Technical Service Bulletin: TSB240188

Released Date: 16-Oct-2025

New Electric Fuel Lift Pump System

Figure 1, Filter Bracket, Part Number 6426058.

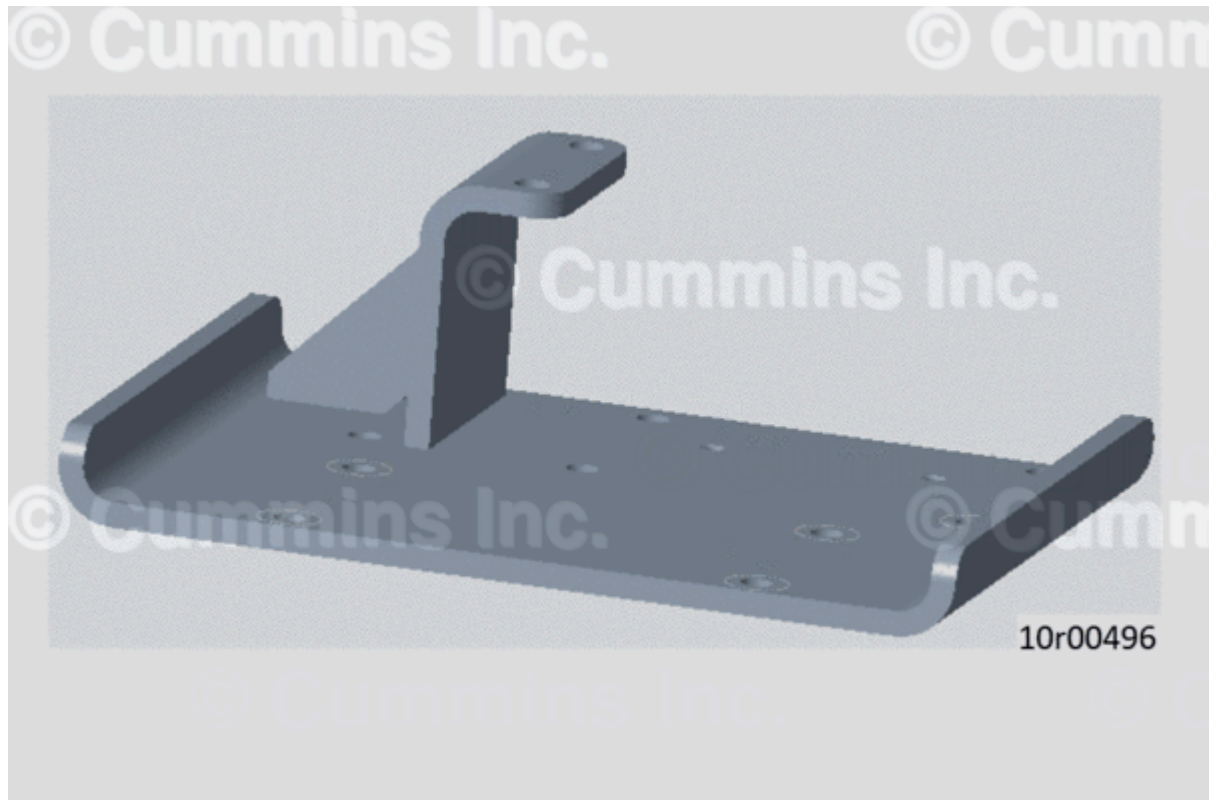
A new electric fuel lift pump system has been released for the product affected. This change includes a new supplier for the fuel lift pumps, an increase from two to three fuel lift pumps per engine, and new relevant hardware. See Table 3. These new fuel lift pumps are added to the Operation and Maintenance Manual, Bulletin 3666134, as maintenance items.

Table 1, Kits/Parts Needed for Conversion from Two-Pump to Three-Pump System		
Application/Configuration	Description	Part Number
Engines built with one of the options: • FF 5079 • FF 5080 • FF 5086 • FF 5088 • FF 5105 • FF 5107 • FF 5108	Filter Bracket (See Figure 1 in Part Identification section)	6426058
Engines built with one of the options: • FF 5081 • FF 5106	Filter Bracket with Air Plumbing Support (See Figure 2 in Part Identification section)	6426729
Service Wiring Harness		
PowerGen (12V System)	Wiring Harness (2 pump to 3 pump – PG 12V to 24V)	6470469
PowerGen (24V System)	Wiring Harness (2 pump to 3 pump – PG 24V)	6470470
Industrial (12V or 24V System)	Wiring Harness (2 pump to 3 pump – IND)	6474493
Table 2, Kits Needed for Fuel Pump Head Reassembly (No Malfunctioning Fuel Lift Pumps)		
Description	Part Number	Quantity
Lift Pump Consumables Kit (3 sets of isolators and seals)	6563611	1
Table 3, Kit Needed for Routine Maintenance and Malfunction Replacements
